Addendum #	02	Date Issued	03/31/2025
Project Name Job #	SWN 0509, Waneta Hall Renovate Restrooms	OSE # R0325--15X	EAPC #20256780
Bid Date Time	April 3, 2025		3:30pm

THIS ADDENDUM AMENDS AND BECOMES PART OF THE CONTRACT DOCUMENTS FOR EAPC PROJECT 20246780 DATED 03/13/2025, RESPECTIVELY. EACH BIDDER SHALL ACKNOWLEDGE RECEIPT OF THIS ADDENDUM BY MARKING THE ADDENDUM NUMBER AND DATE ON THE BID FORM.

1 CRAWL SPACE ELECTRICAL PLAN
E200.1 1/16" = 1'-0"

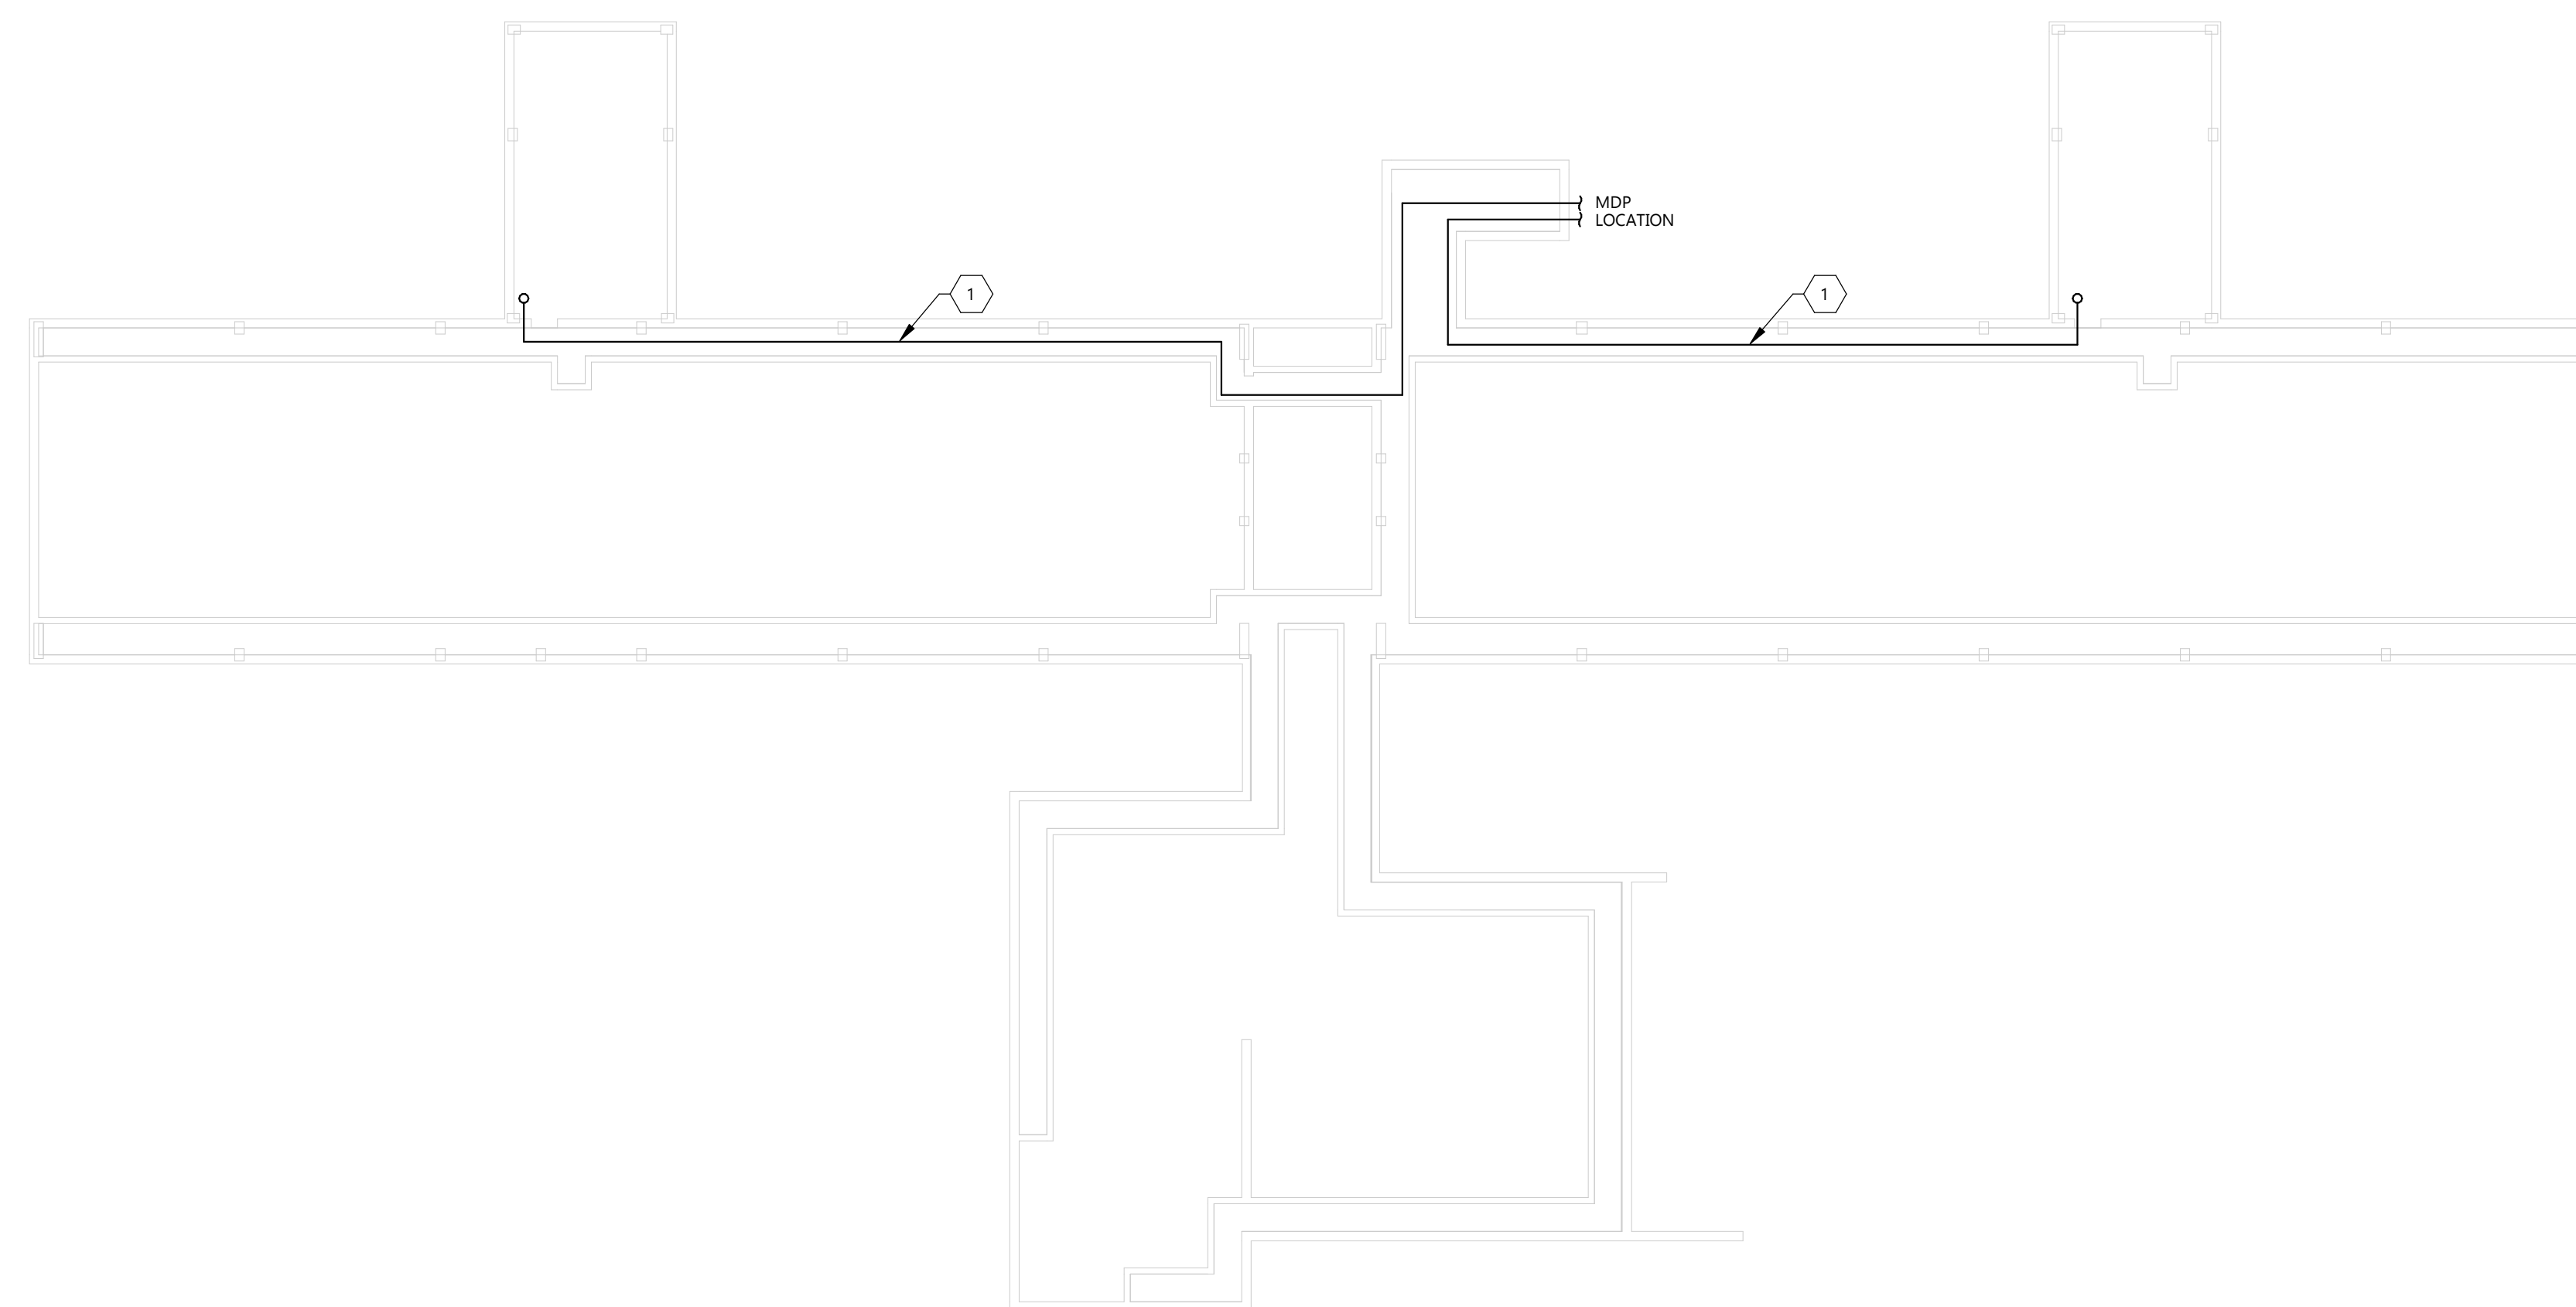
- E200.1 Sheet added for clarification on conduit routing for feeders to 2nd floor to be routed through crawl space.
- E202 Note 5 added for clarification on relocated data panel.

2 THIRD FLOOR POWER & SYSTEMS PLAN - MENS 
E203 1/4" = 1'-0"

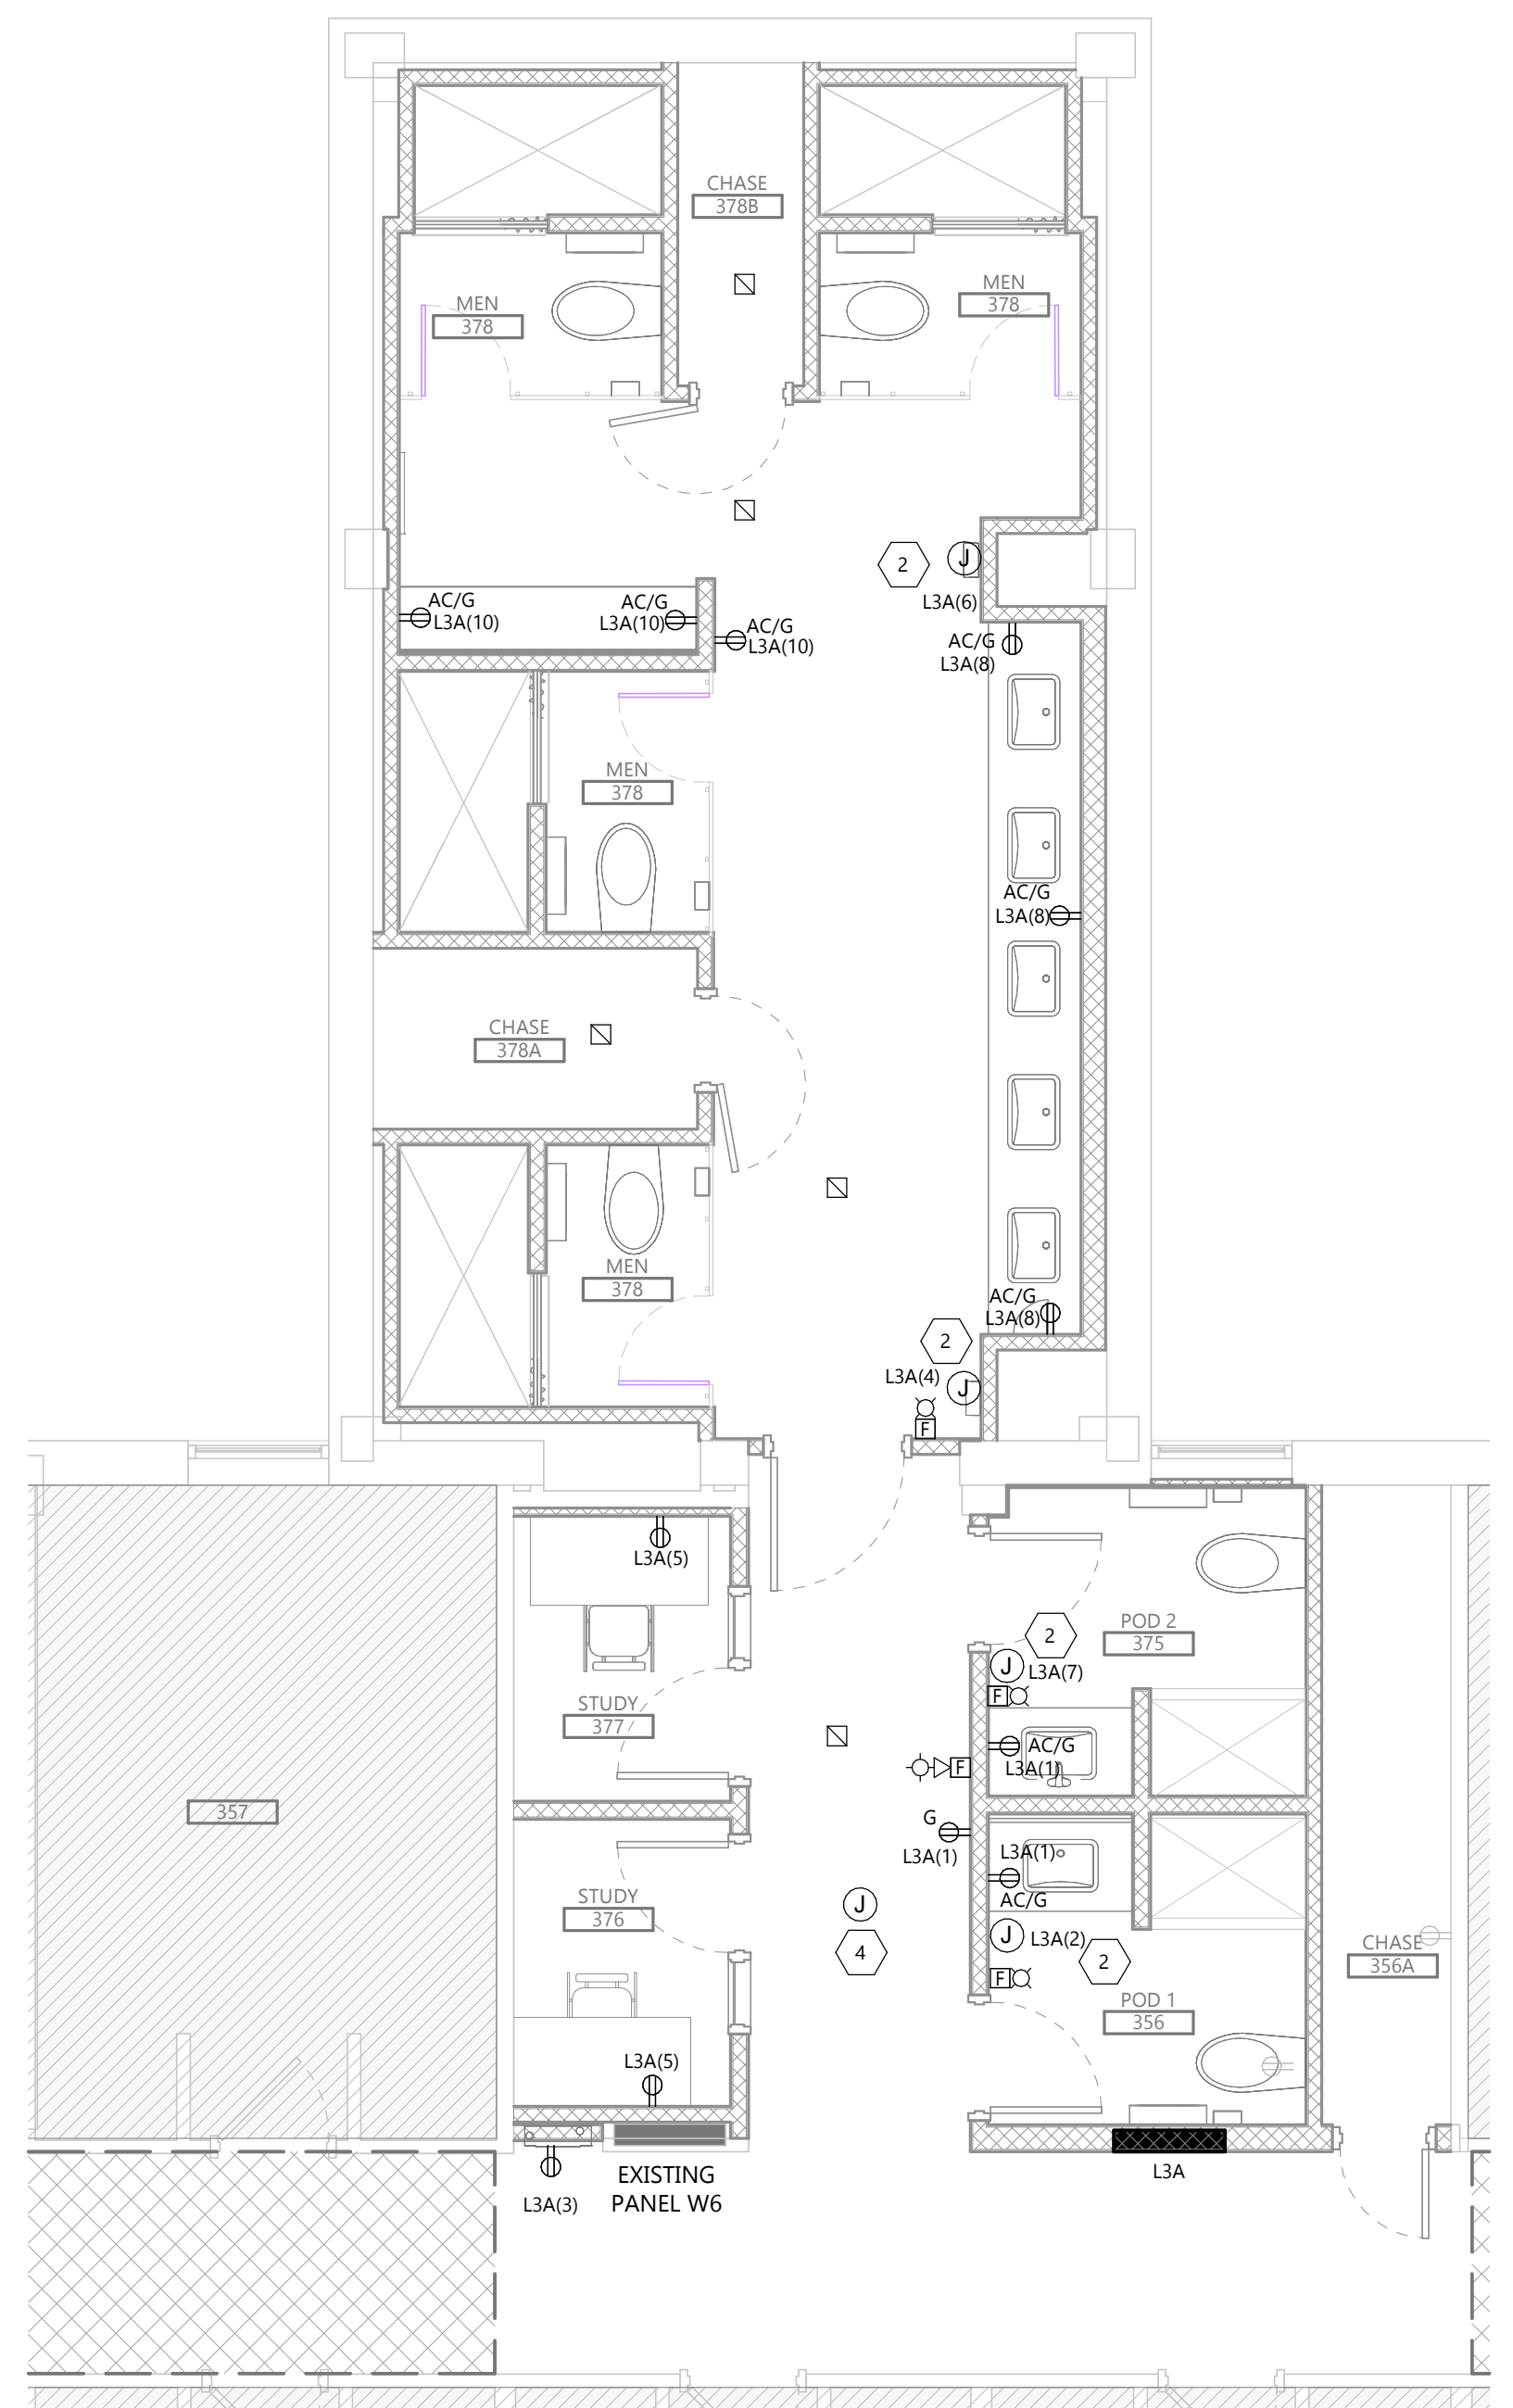
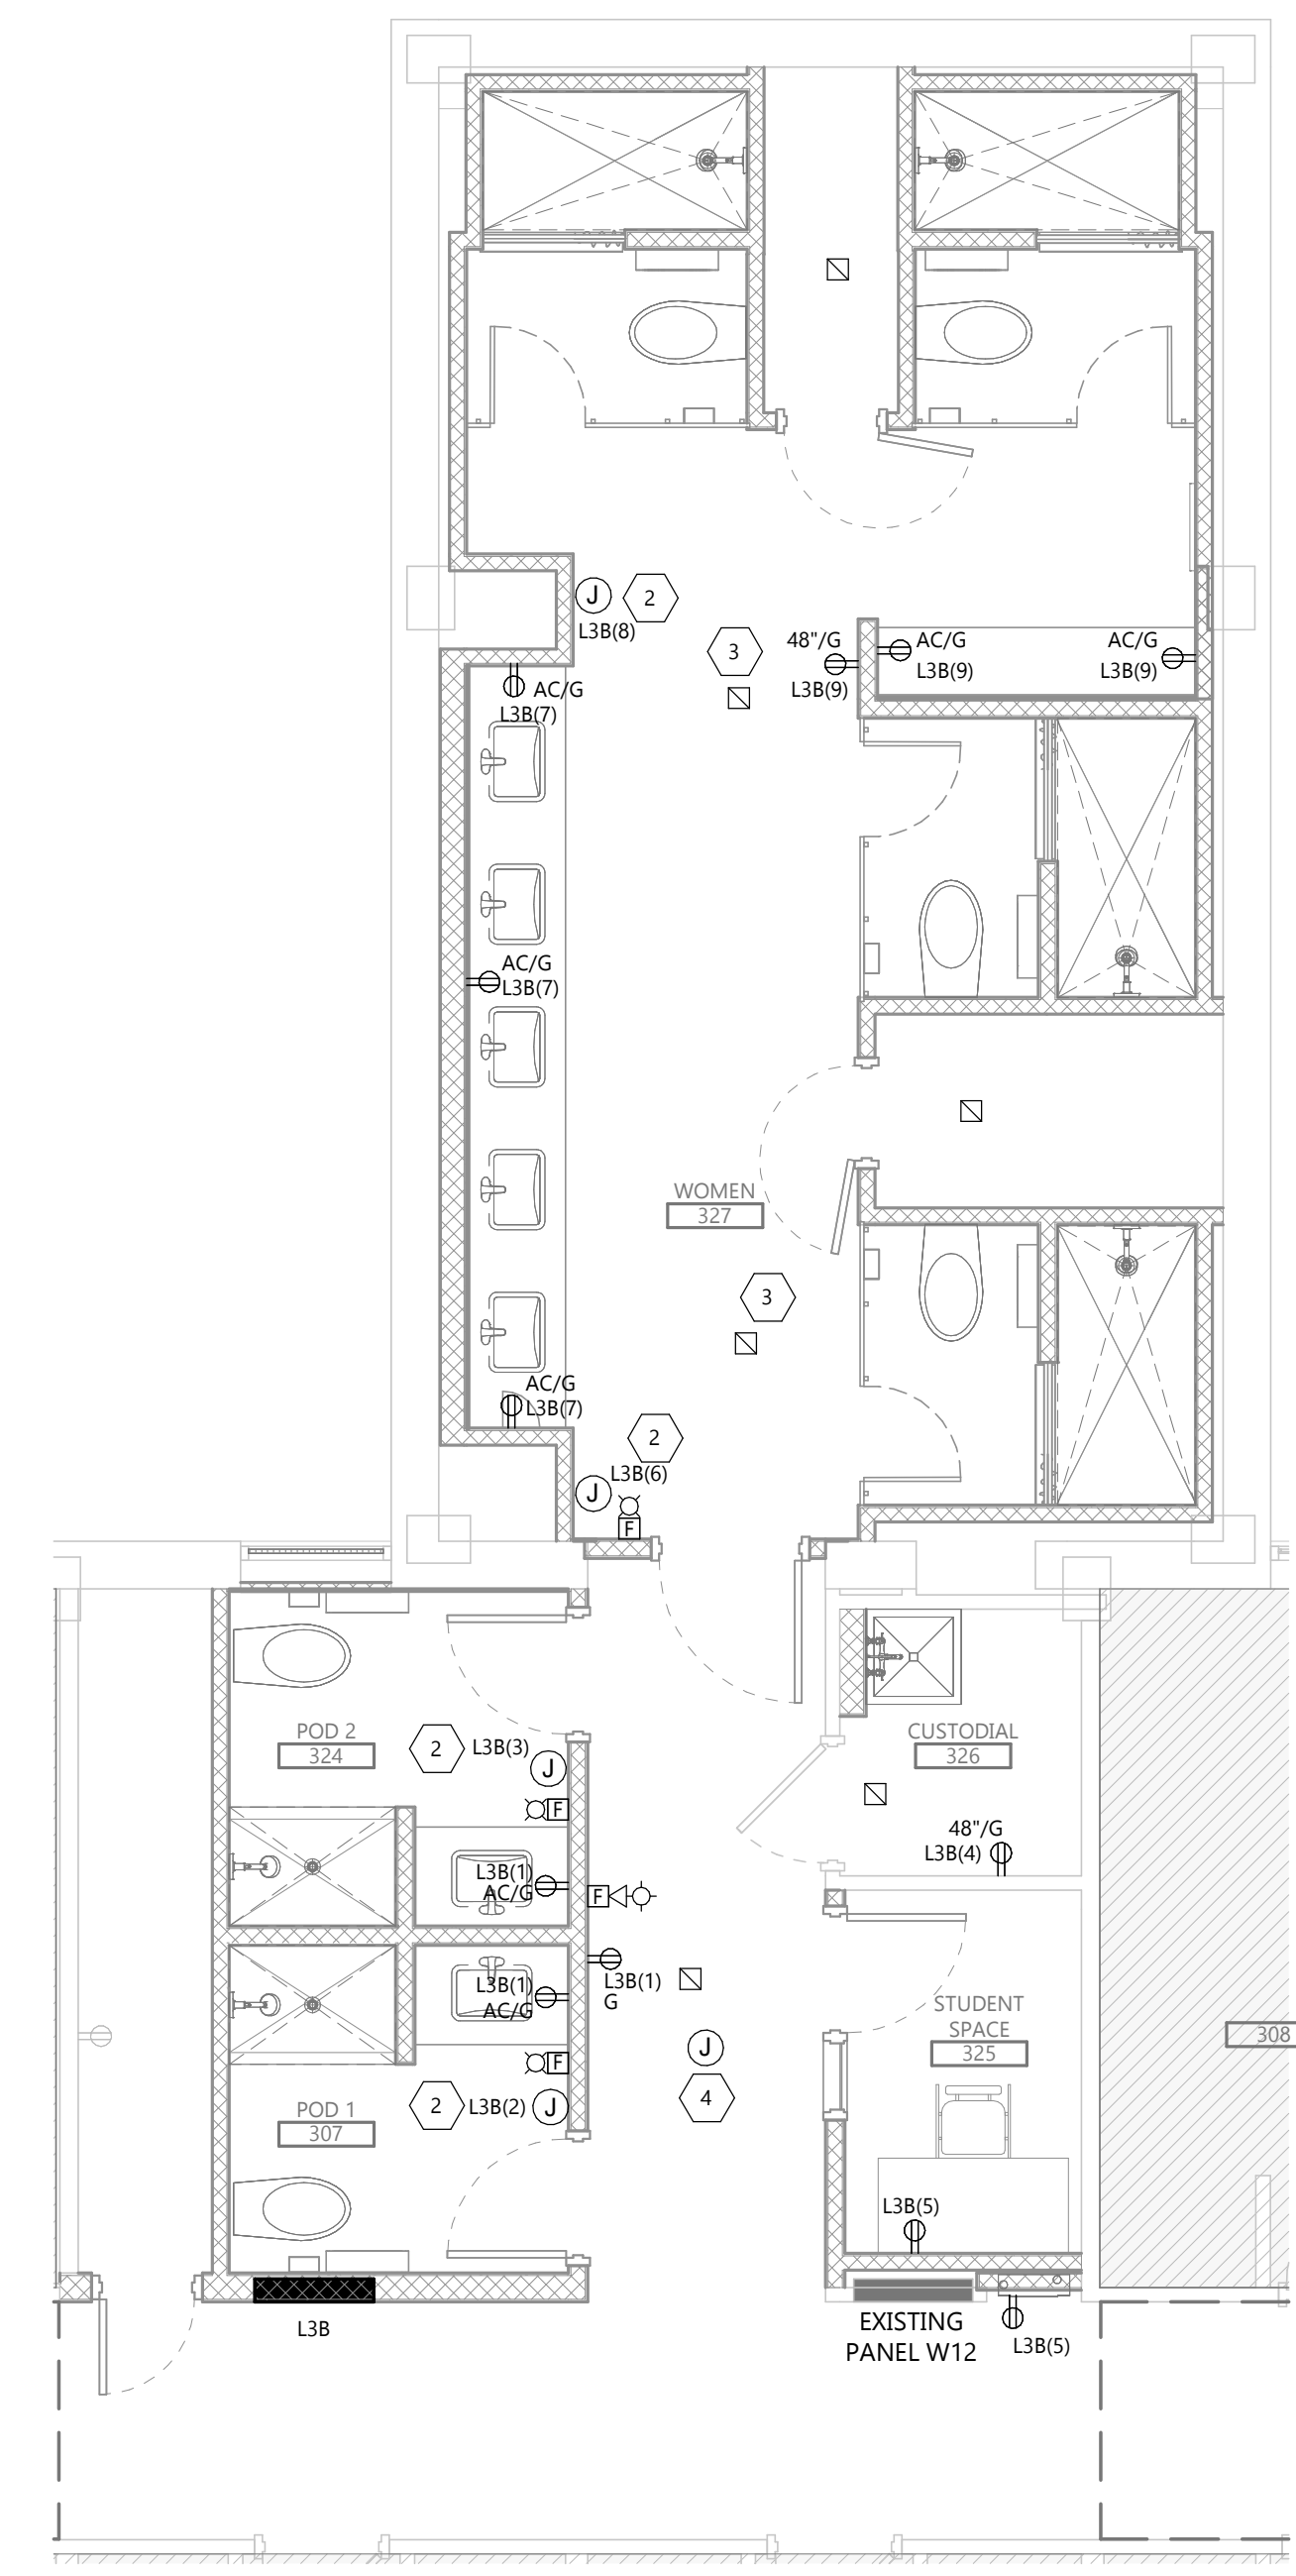
E203	Note 5 added for clarification on relocated data panel.
E304	Add A3 fixture and connect to circuit W3B(31).
E802	Provide six (6) extra C1 lights for Owner attic stock. Add V1 fixture.
